# ***UTS Central Project***

*State Significant  
Development  
Modification Assessment  
(SSD 7382 MOD 3)*

December 2018

**Figure 2** | Ventilation shaft requirements (Source: Response to Submissions)

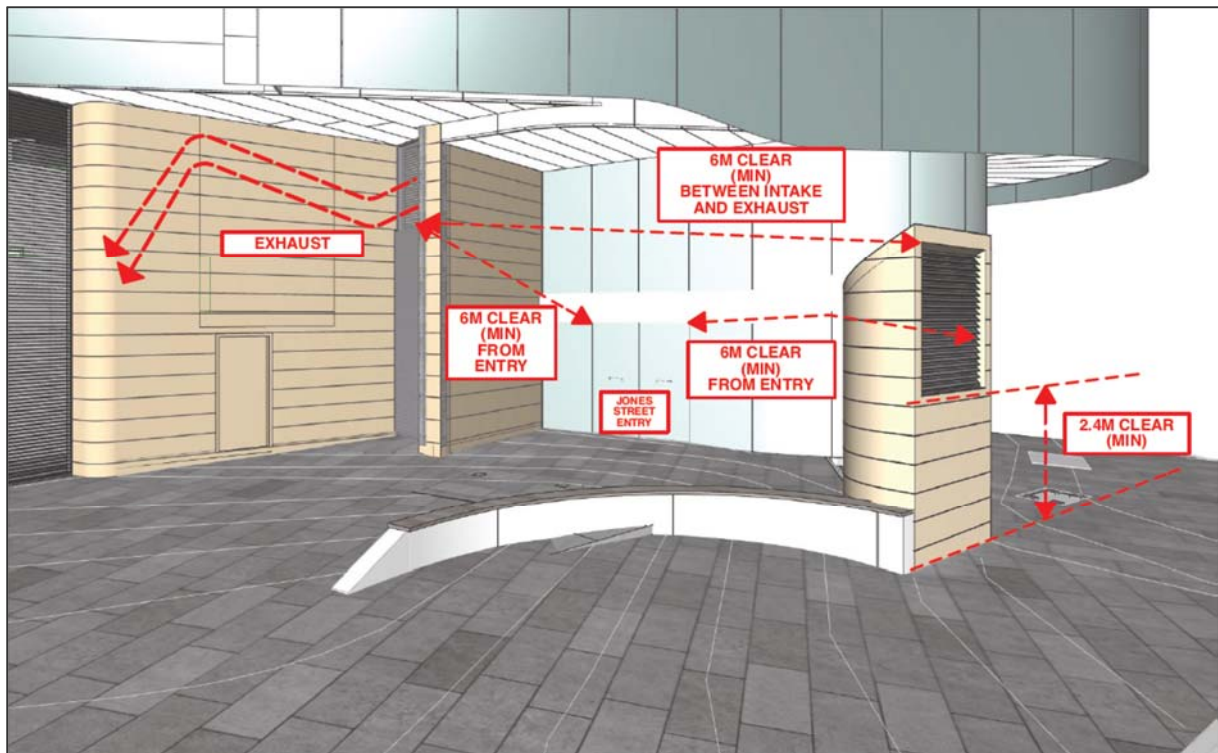
Additional ventilation shafts are proposed to ventilate the basement substation located in the vicinity of Jones Street. Ausgrid requirements mandate two shafts with louvres for inflow ventilation and outflow exhaust to the approved electrical substation (refer to **Figure 2**) at a maximum 10m from the substation. The inflow ventilation shaft is proposed to be located away from the building facade with a height of 4.9m and width of 2.5m, with the louvre panel facing Jones Street. The outflow exhaust shaft has been integrated into the Jones Street façade. The ventilation shafts are proposed to be rendered and painted to match the Alumni Green façade. The modifications also result in changes to the pathway requiring four new steps between the shaft and the Jones Street entrance.

- integration of the ventilation shafts with the design of the building, particularly the stand-alone intake ventilation stack, which is a prominent and unsightly addition within the public domain. Further investigations should to find a more suitable location and/or design for the shafts should be undertaken.
- confirm accessibility requirements in the Australian Standards have been met in relation the public domain at the corner of Broadway and Jones Street entrance given the additional steps.

The Department considers this satisfactory given alternatives were considered, the technical requirements of Ausgrid (as shown in **Figure 2**) and the commitment to further mitigate the visual impacts as part of the envisaged public domain improvements to Jones Street. The Department recommends that the condition requiring the Jones Street upgrade be modified to include consideration of treatment of the ventilation stacks.

**Figure 8** | Proposed 17 Layout (Source: SSD 7382 MOD 3)

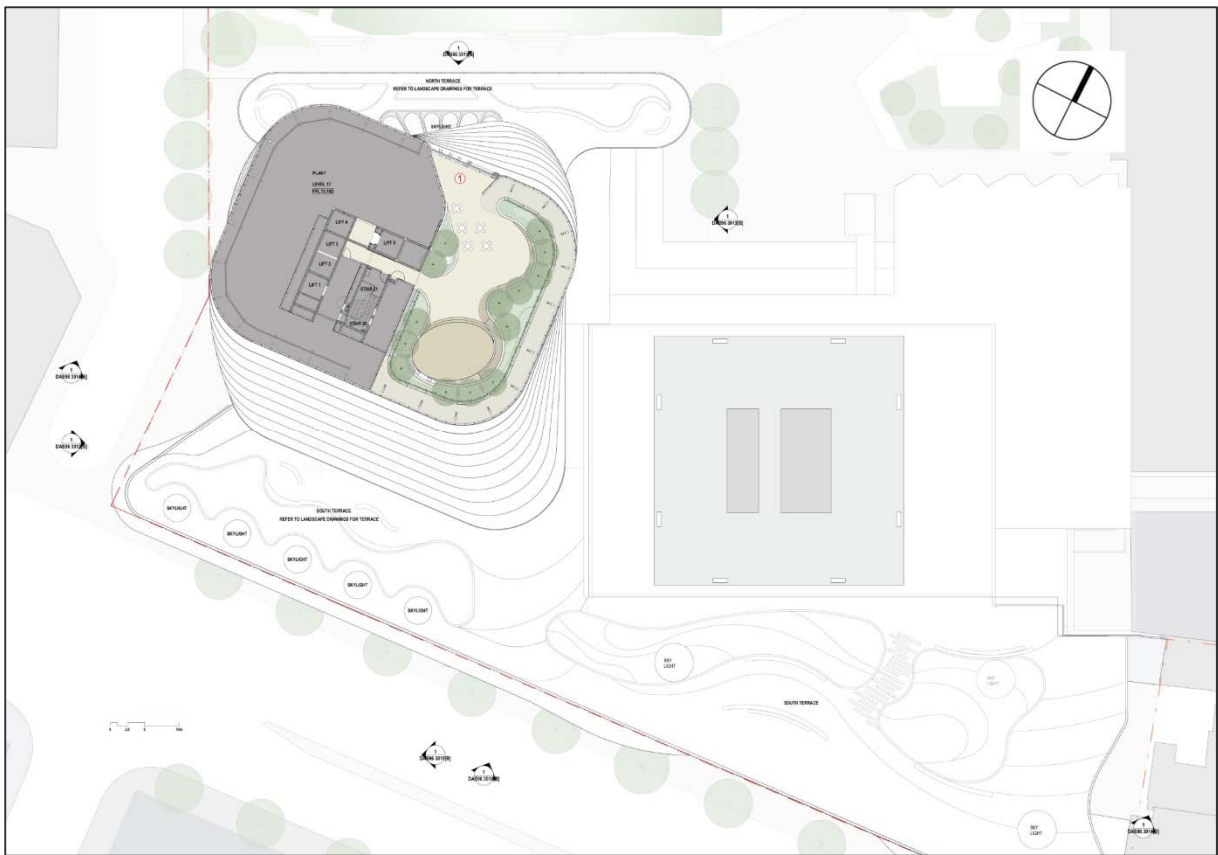
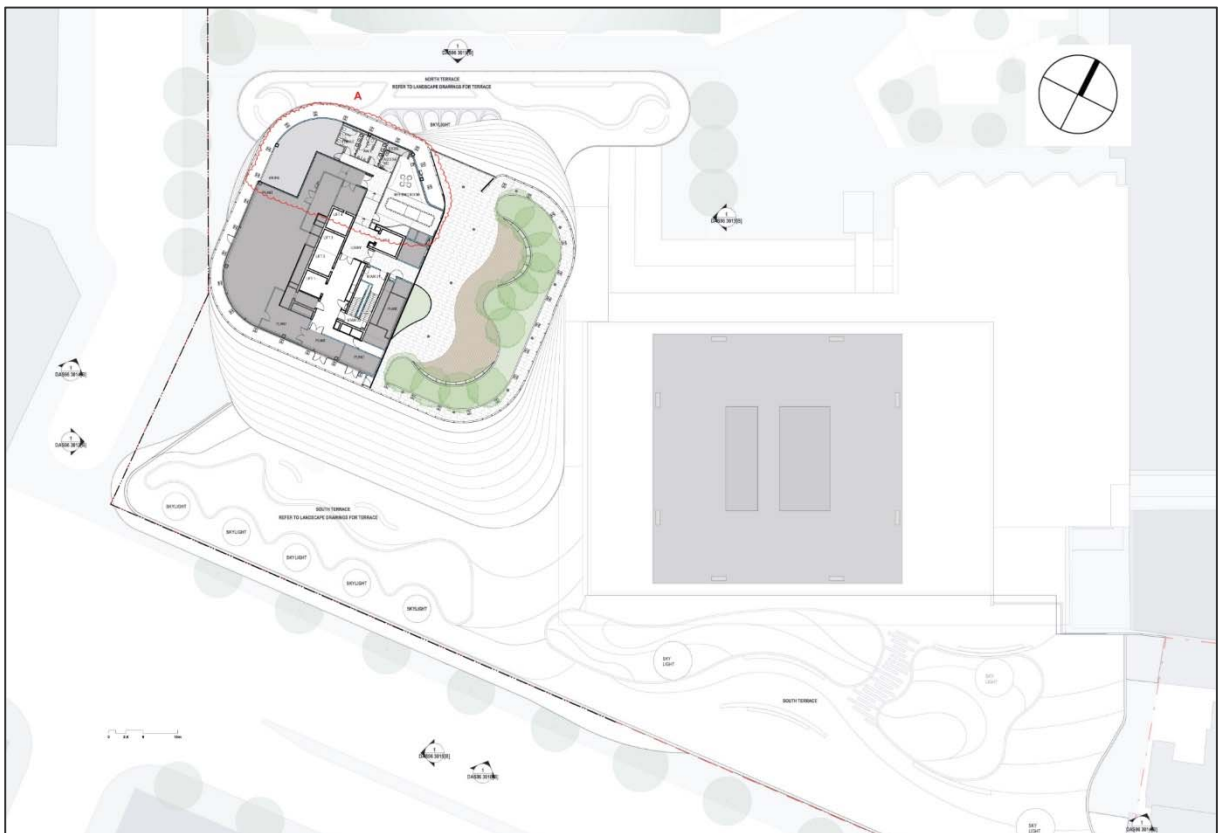
Minor amendments are proposed to provide a meeting room, two store rooms and bathrooms on Level 17 where the plant area has been refined through the detailed design process. The modifications result in a minor increase in gross floor area (GFA) of 146sqm.

**Figure 10** | Proposed Jones Street (Western) Elevation (Source: SSD 7382 MOD 3)

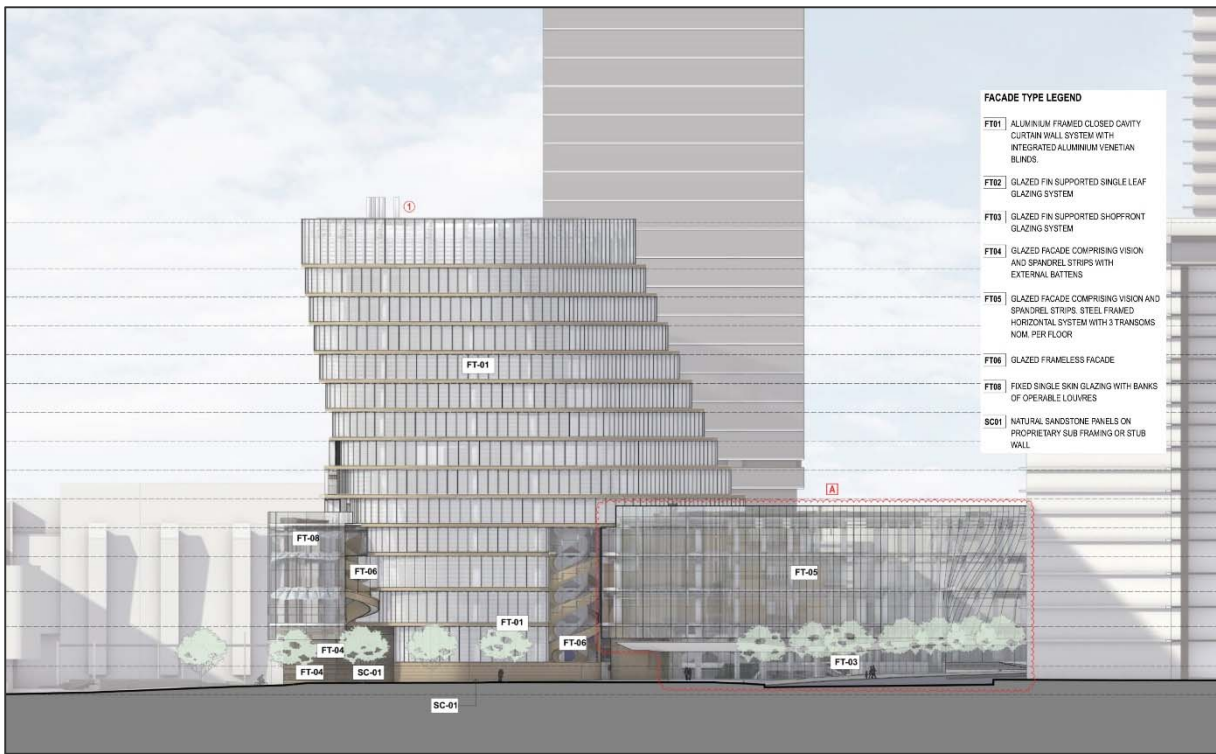
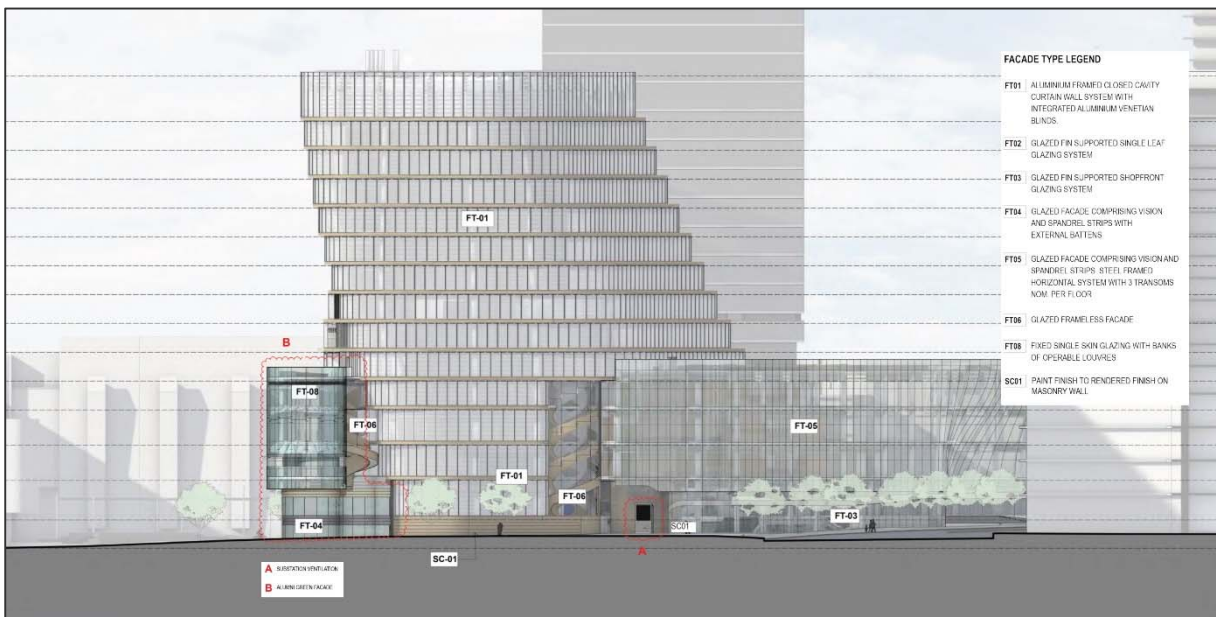
The RtS was referred to Council for review. Council restated its concerns with the proposed standalone ventilation stack in the public domain area off Jones Street.

The visual impacts on the public domain from the ventilation shafts are being mitigated through use of a curvilinear form and a rendered and painted finish that is consistent with the base building to enable the stack to blend into the background. The Applicant has also indicated that it is committed to exploring opportunities as part of the future Jones Street upgrade to integrate and minimise the visual impact of the intake ventilation stack, including potential integration with artwork/sculpture, signage and wayfinding, or screening through landscaping.

Whilst the additional steps would also result in a longer accessible path of travel from Broadway, an accessible path of travel is maintained. The Department raises no objection to the additional steps within the Jones Street pathway.
